City Commission Work Session

Page by page review of OAO zoning code.

**OAO ZONING CODE DRAFT
4.13.2021 VERSION**

Figure 1 – Allowable Building Envelope Cross-Section:

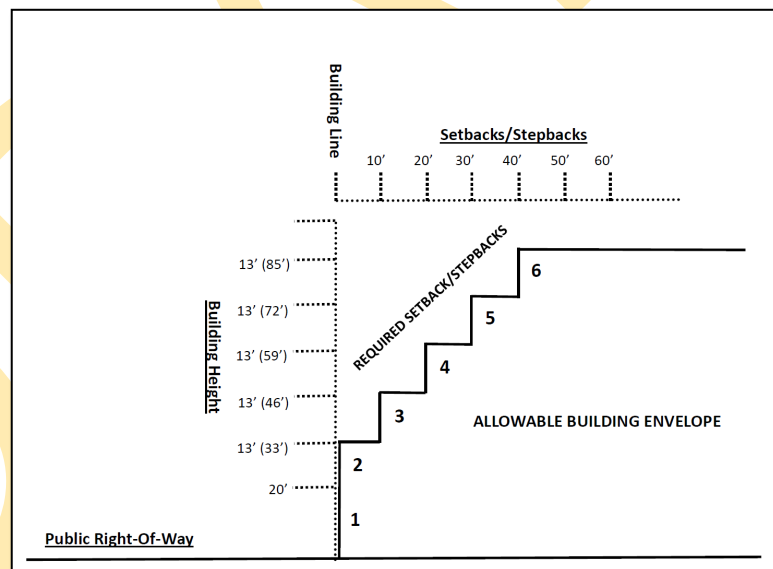
For Figures 1 and 2 – use same scale for horizontal and vertical axes

Sullivan	8,9	Figures 1 & 2	Use same scale for horiz and vert axes	As pictured distorts step back.	
Sullivan		10 Fig 3 "add'l setback"	specify "build-to" consistency	This keeps uniformity and prevents set back for taller building face.	
Sullivan		10 "Additionally, . . . 3 stories"	delete sentence.		
Sullivan		11 setbacks	add: "setback greater than build-to line subject to variance approval."		
Sullivan		14 "City-retained prof. architect.."	delete. Require a committee.	Review committee requirements.	
Sullivan		16 j.(7) park struct. count as FAR?	If any condition is not met, then excluded from FAR?		
Sullivan		18 L. open space		See example Orlando, Orange Ave & Church	
Sullivan		19 m.(2) & (4)	65% green space? What about 50%?	St, 5% green.	
Sullivan		20 "Localized Mobility Fee"?	7.5', match Park Ave.		
Sullivan	pp. 3. and 21.	maps	match the boundaries.		
Sullivan		21 para. 2	add . . . "limited to open space . . ."

Figure 2 – FDOT Roadway Setback/Stepbacks (17-92 & Fairbanks):

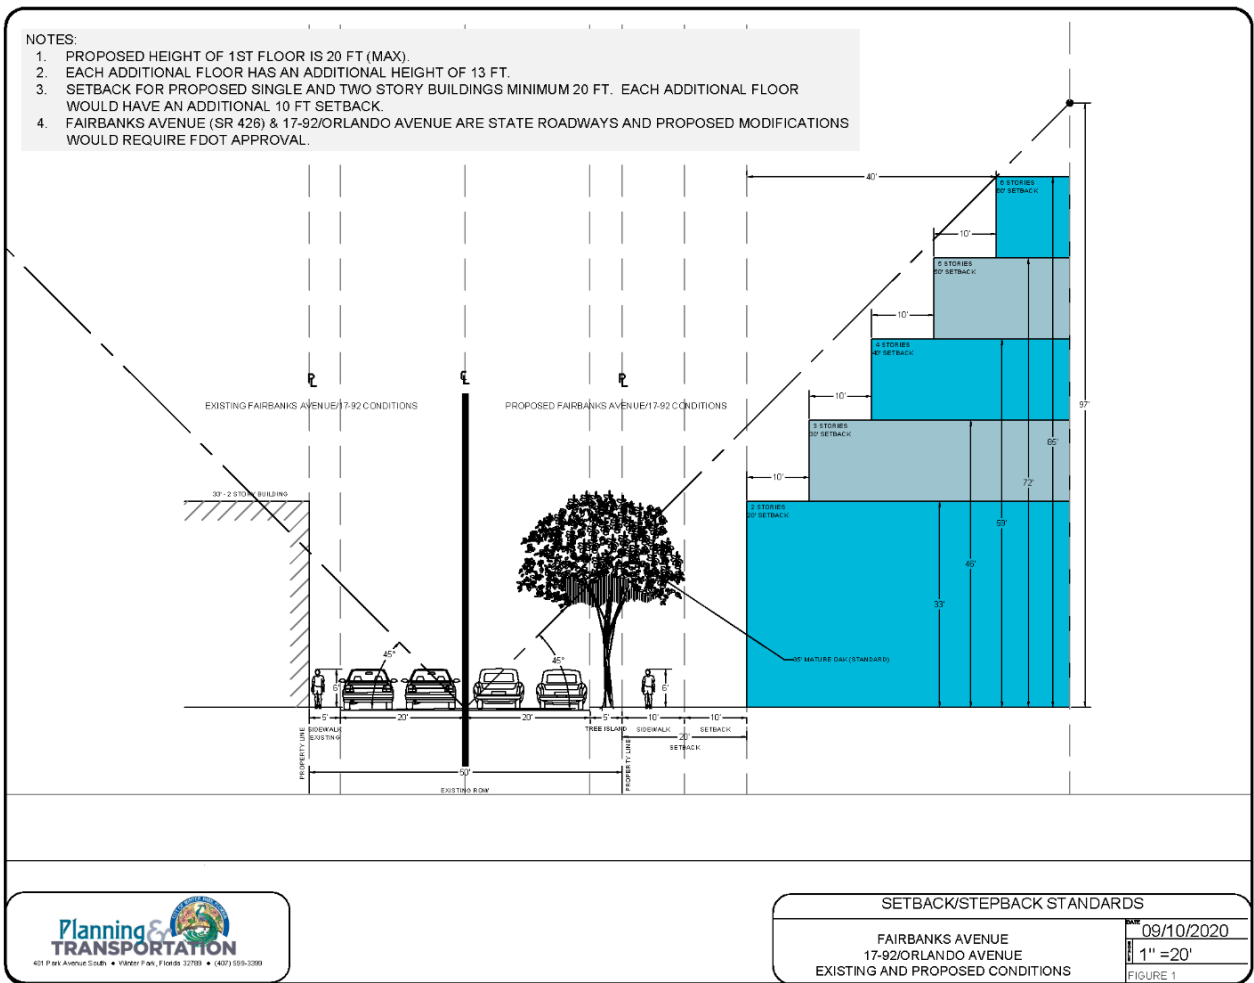
Change floor to ceiling height to match code. Change from state roads to all roads for 10 ft stepback.

Discuss setback from Fairbanks and goals of the sidewalk. Need to consider Transit preferred lane width, safety and intention of the sidewalk, also consider the Maitland and Paseo actual setbacks.

14										
15	Cooper	10	j.(2) Setbacks/Stepbacks	Update Figure 2/3 to increase setback to 10ft and delete any floors not permitted by code.		OK.				
16	Anderson	10	j.(2) Setbacks/Stepbacks	Clarify "All setbacks of additional floors shall be measured from the allowable building line"		Discuss				
17	Anderson	11	Setbacks/Stepbacks, Also Subarea J, B, A	Figure 2- Discuss setback from Fairbanks and goals of the sidewalk. Need to consider Transit preferred lane width, safety and intention of the sidewalk, also consider the Maitland and Paseo actual setbacks.		Discuss				
18	Cooper	12	Setbacks/Setbacks	Clarify "space for healthy development of shade tree crowns" by adding: "Setbacks on street frontages shall provide a minimum 25 ft from the center of the planting strip to the front of the building." (D Lamn Jan21).		Discuss				
19	Cooper	13	Setbacks/Setbacks	While setbacks are not required from Railroad ROW, add "Setbacks are required from bike/pedestrian trail to allow space for healthy development of shade tree crowns. Shade trees shall be placed not more than 50 feet apart along the trail."		Discuss

Figure 3 – Typical Cross-Section for Orange Avenue Setback/Stepbacks

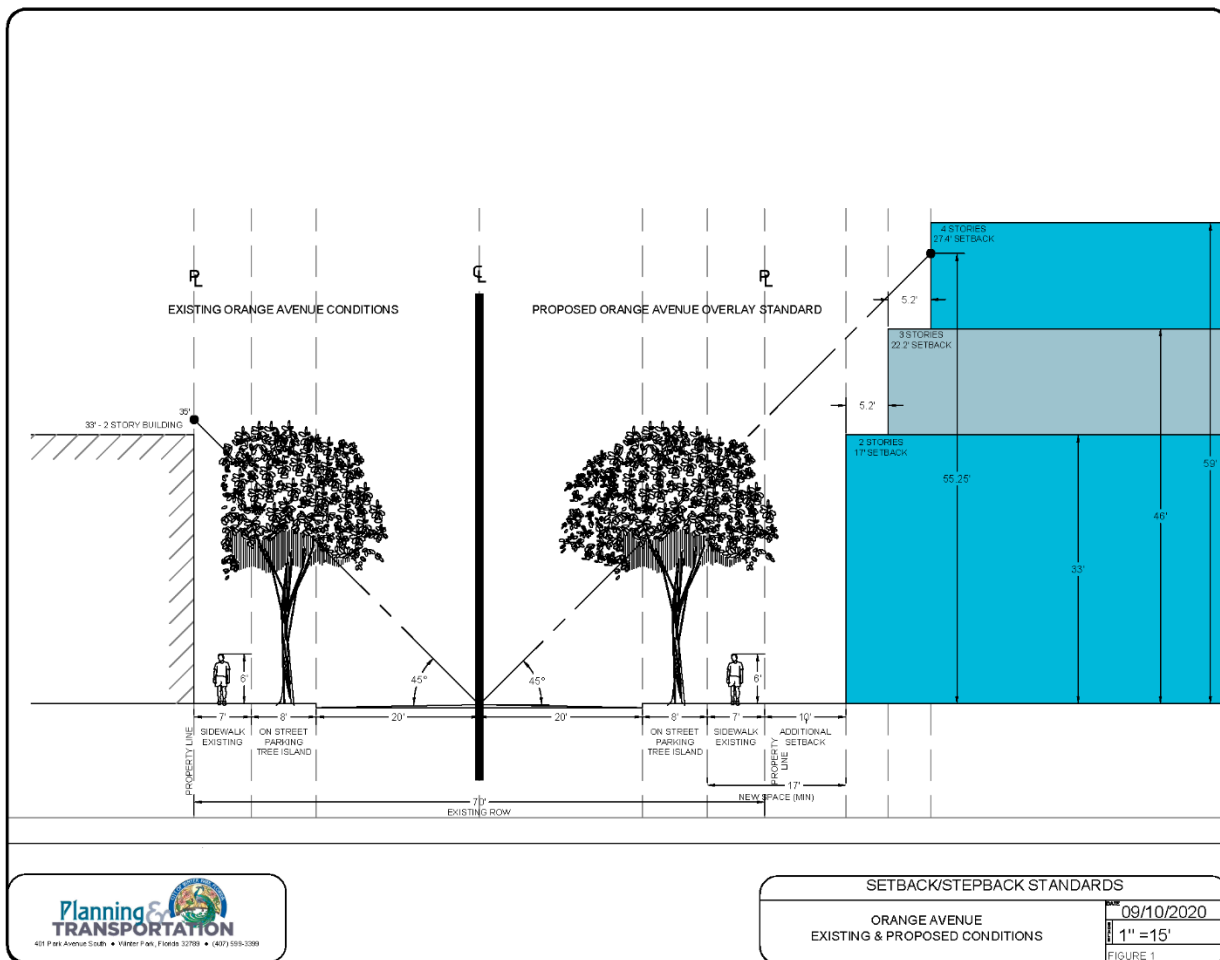
Update Figure 3 (says 1 on drawing) to show 10ft not 5ft. Delete the third story on Orange Avenue. Specify build-to consistency on Figure 3
